**Replacement Pages of Air Ventilation
Assessment**

**Proposed Commercial
Development at Caroline Hill
Road, Hong Kong**

**Air Ventilation Assessment – Initial
Study**

Issue 2 | April 2024

Figure 30 Proposed Scheme – GF Layout Plan

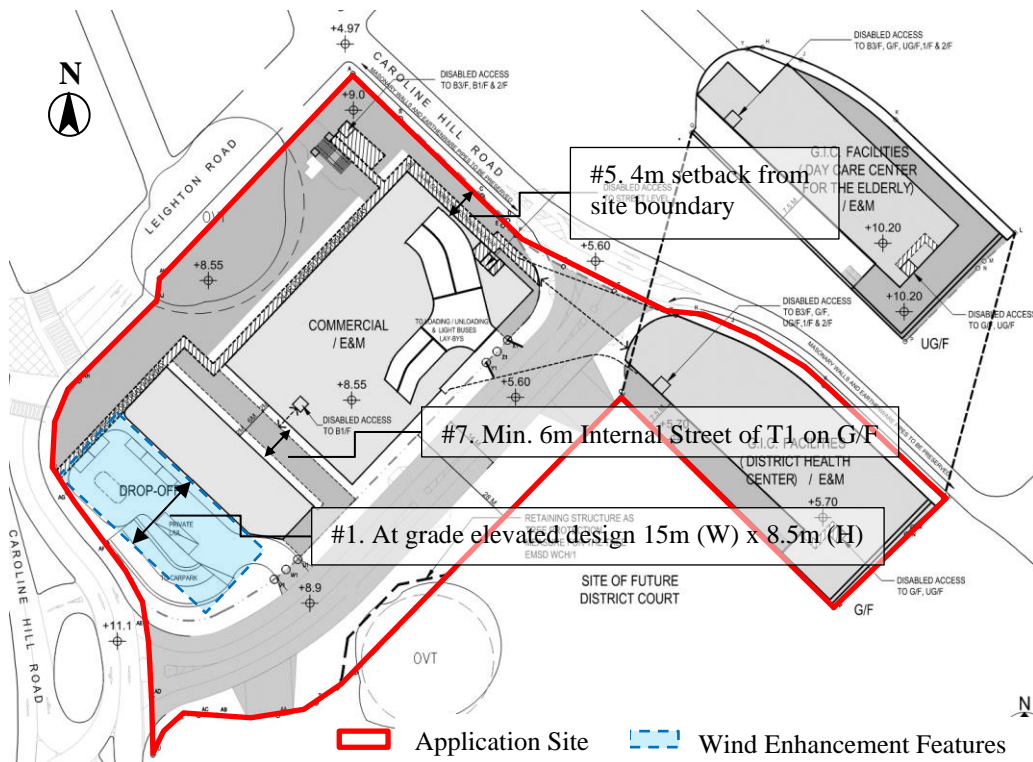
Note 2: Approx. min.16m (W) x 10m (H) amended elevated design as discussed in Section 4.2.

Figure 36 Amended Elevated Design on 2/F of T3.

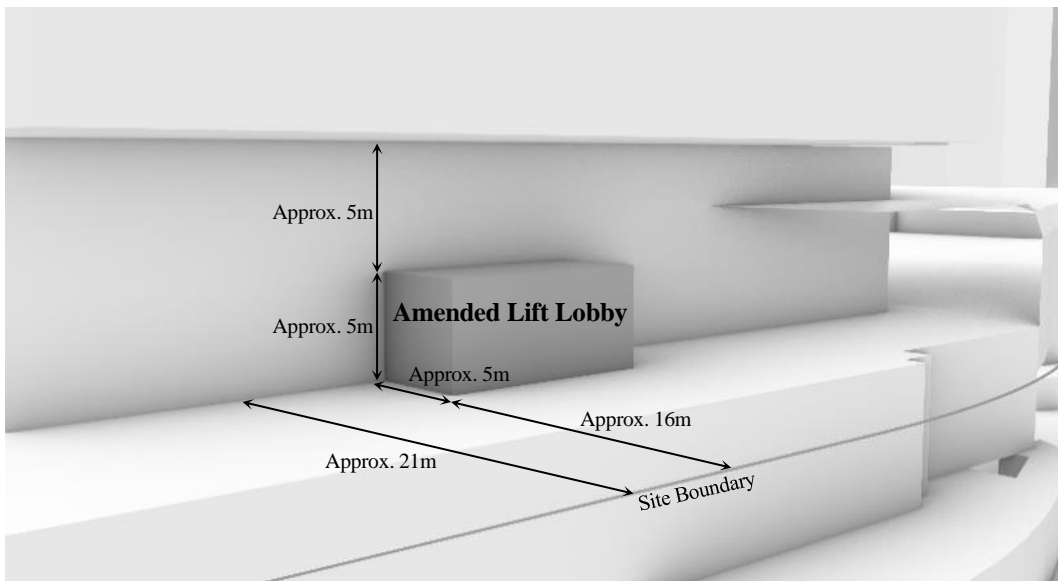
As the design continue to develop, the lift lobby on 2/F of T3 is enlarged to allow more room for pedestrian flow. Hence, the wind enhancement features #3 is slightly amended.

The amended elevated design on 2/F of T3 varies from approx. 21m widest to 16m narrowest with a height maintained with approx. 10m. An additional void with approx. 5m (W) x 5m (H) is located above the amended lift lobby as illustrated in Figure 36.

Minor amendment on wind enhancement features #3

For the amended elevated design on 2/F of T3, two incoming air streams would be concerned including incoming wind from eastern side along Caroline Hill Road and from the south-western side.

For incoming wind from eastern side, the amended lift lobby is a minor extension from core structure and away from the north-eastern site boundary, which minimize the blockage. The elevated design with at least 16m (W) x 10m (H) are free of obstruction for eastern wind. With additional 5m(W) x 5m (H) void atop the amended lift lobby, the effectiveness of the void would be insignificantly affected. Wind from eastern side would still be able to flow through underneath the tower and the influence on Caroline Hill Road would be minimal.

For incoming wind from south-western direction, the elongated shape of core structure would dominate the wind environment and cast a localized wind shadow at the elevated area under T3. The amended lift lobby would fall within shadow zone and the influence from the amendment on ventilation performance would be insignificant.

An amendment on 2/F of T3 were proposed as the design develop as illustrated in Figure 36. A qualitative discussion is provided in Sections 5.1 and 5.2. The overall ventilation performance along the Site Boundary and Assessment Area due to the amendment would be minimal with confined difference near the amended lift lobby. The quantitative analysis and conclusion in this AVA would remains valid.
